Planning and Development (William Hovell Drive Duplication – Blocks 1385 and 1565, Belconnen) EIS Assessment Report 2024

Notifiable instrument NI2024–363

Environmental Impact Statement Assessment Report

William Hovell Drive Duplication
June 2024

**WHD Duplication
Year 2031 Noise Levels
(with road surface mitigation)**

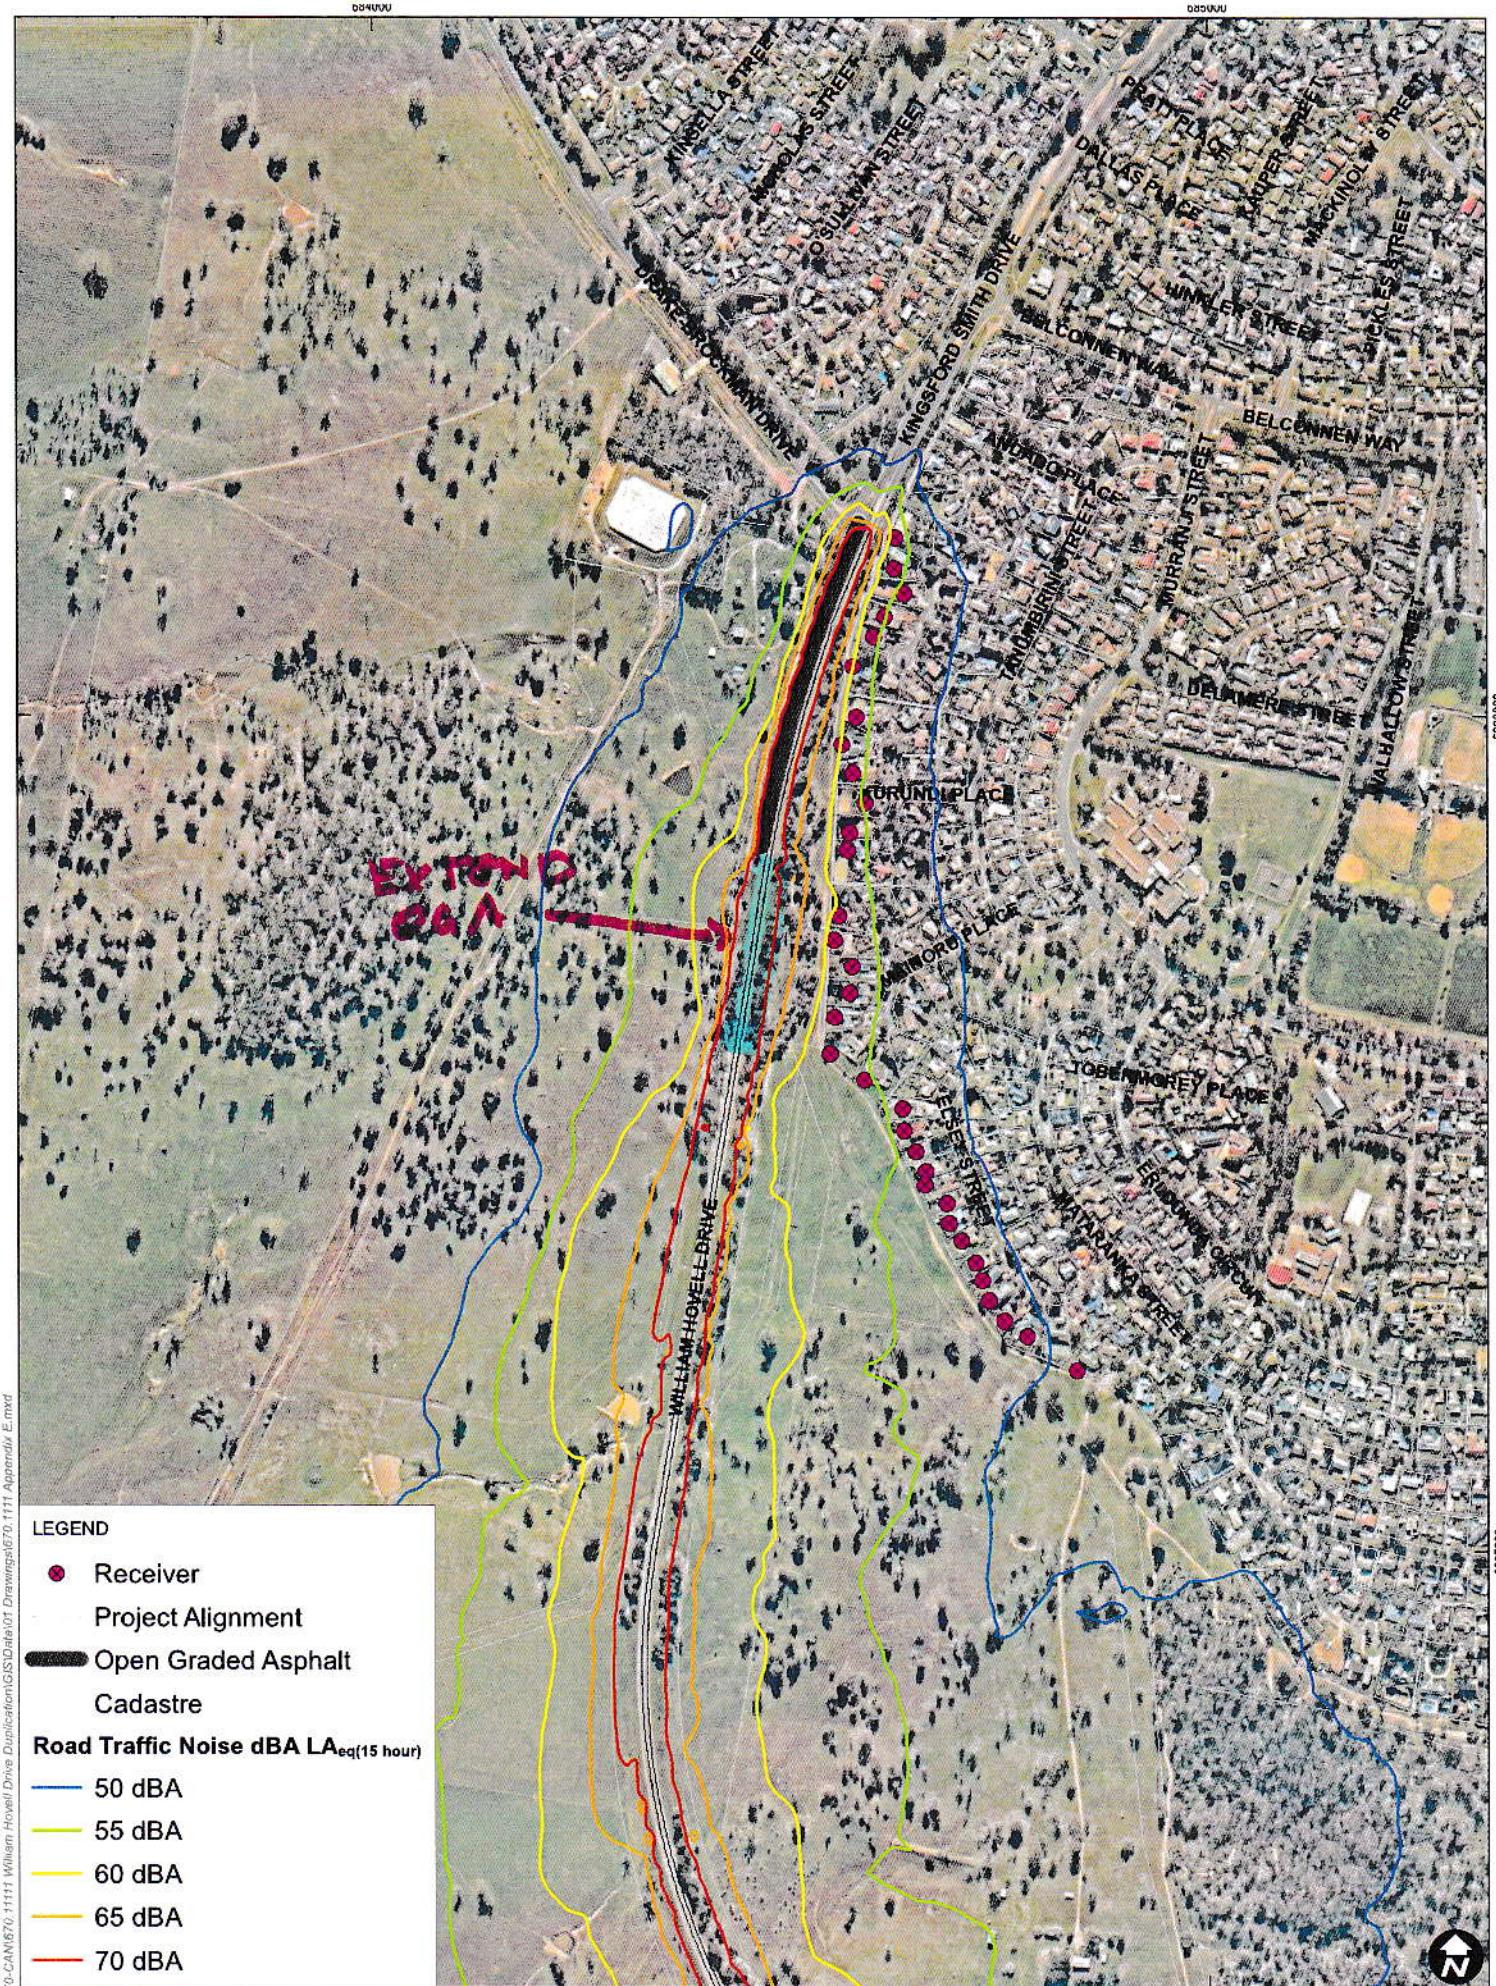
**SUGGESTED REALIGNMENT TO
RETAIN ATTRACTIVE STAND OF
EUCALYPSUS**
